List of changes from consented scheme:

Client Sign Off	Architect/Originator: Tate Harmer	Unit G182, Stamford Works, 3 Gilt Street, London N16 8JH Tel: +44 (0)207 241 7481 Email: studio@tateharmer.com	Do not scale. All dimensions to be checked on site. This drawing is copyright.
	Class: Platinum Land	8 Overpel House, 1 Duke of York Square, Kings Road, London, SW3 4LY	Date of Origin: 28.11.17
	Project: Belsize Park Firestation		Drawn By: TS
	Drawing Title: Proposed Basement Plan		Scale: 1:100 @ A1
	Drawing Number: BFS THA PR AL 090 P4		Revision: Planning

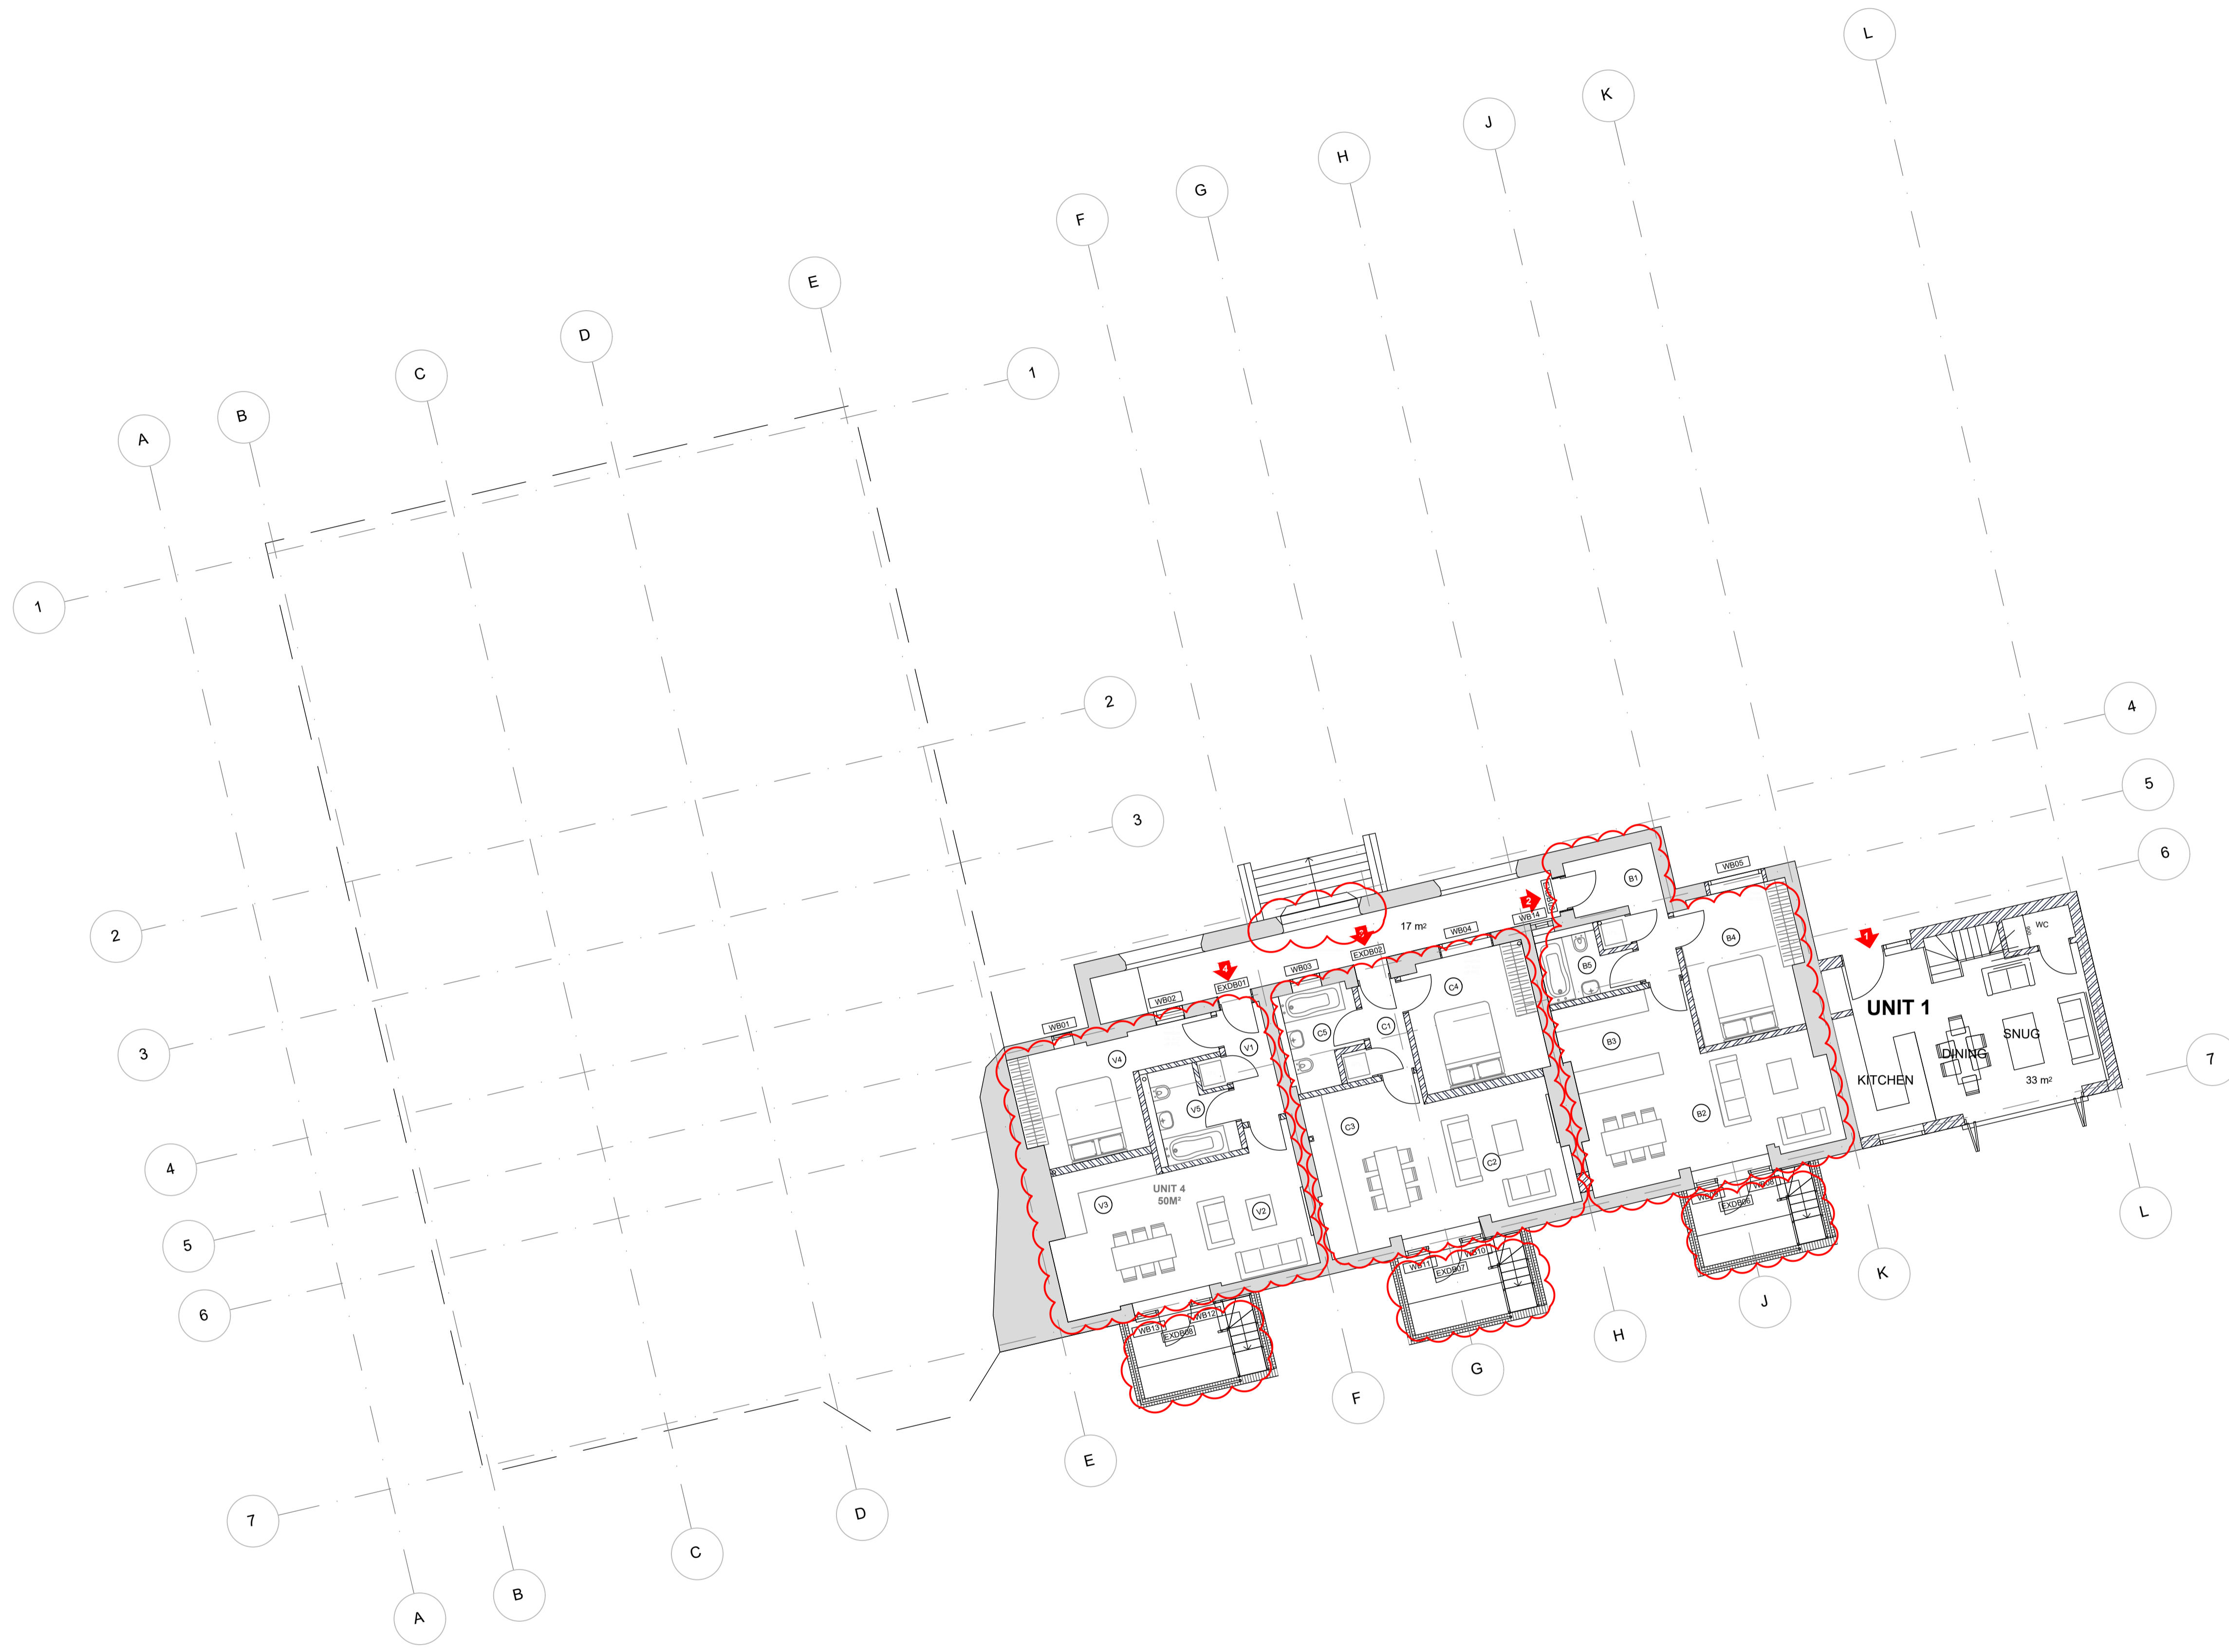
- Unit 1 - As per consented scheme. Please refer to NMA for unit 1.
- Unit 2 - Amendments to internal layout. Basement FFL lowered by 85mm. Amendments to lightwell stair and wall.
- Unit 3 - Amendments to internal layout. Basement FFL lowered by 85mm. Amendments to lightwell stair and wall.
- Unit 4 - Amendments to internal layout. Basement FFL lowered by 85mm. Amendments to lightwell stair and wall.
